30-045-06373 ANGEL PEAK #002

SOUTHLAND ROYALTY COMPANY LLC

PROPOSED P&A PROCEDURE

Re: Permanent Abandonment
Well: Angel Peak 2

PROPOSED P&A

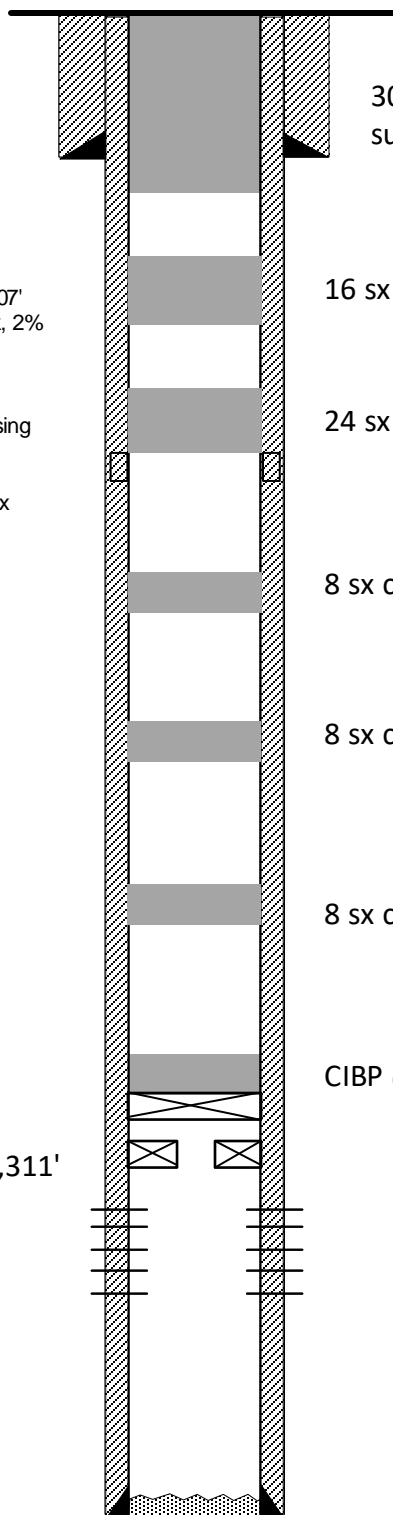
- Extend the Mancos plug: 4615'-4450'. OCD Mancos pick @ 4565'.
- Extend the Mesaverde plug: 3420'-3200'. OCD Mesaverde pick @ 3370'.
- Include the Chacra plug: 2720'-2620'. OCD Chacra pick @ 2680'.
- Ensure the P.C. and Fruitland are plugged: 1840'-1500'. OCD P.C. pick @ 1790'. OCD Fruitland pick @ 1560'.
- Ensure the Kirtland and Ojo Alamo are plugged: 835'-600'. OCD Kirtland pick @ 785'. OCD Ojo Alamo pick @ 650'.

3. Ensure all plugs pumped meet FFO General requirements. Minimum inside plug 100 ft plus 50ft excess. Please review the General Requirements document to ensure volumes meet required excess inside and outside casing.

4. Submit electronic copy of the CBL for verification to the following addresses: jkillins@blm.gov , jhoffman@blm.gov and Brandon.Powell@state.nm.us . Based on CBL review, inside/outside plugs and volumes may be adjusted accordingly. Formation tops will be based on attached geologic report. Do not proceed with further operations until review of CBL is complete.

5. BLM picks top of Fruitland at 1250' md. Adjust volumes or add and additional plug to cover Fruitland formation top 1200' to 1300' md.
6. Adjust or add and additional plug to cover Pictured Cliffs formation top 1742' to 1842' md.

- Please ensure that the tops of the Pictured Cliffs and Fruitland formations as well as the entire Ojo Alamo aquifer, identified in this report, are isolated by proper placement of cement plugs. This will protect the freshwater sands in this well bore.
